Service Technical Information

MODEL NO.	AM-F70 / F65
SUBJECT	"Caution!" display appears.

REF.No. :G - 99 - 019 - E0

DATE :02. JUN. 1999

Fig. 1

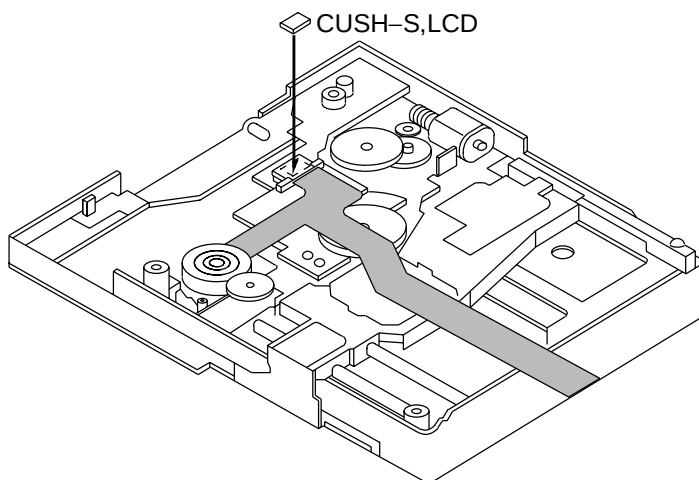
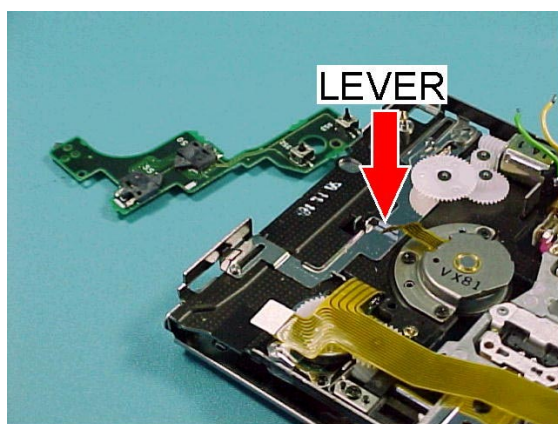
This symptom occurs when μ -COM fails to detect on/off of OWH UP(S50)/DOWN(S51) SW.

- If on/off detect of a switch fails even though the OWH position detect switch is pressed:
Replace the detection switch with new one.
- If the lever runs on to OWH UP SW(S50) (See Fig.1):
Remove the lever away from the switch, and then affix a cushion (CUSH-S, LCD) on to the connector of PWB, MECH (CN50).

If that is the case, replace the two switches, S50 and S51 with new ones.
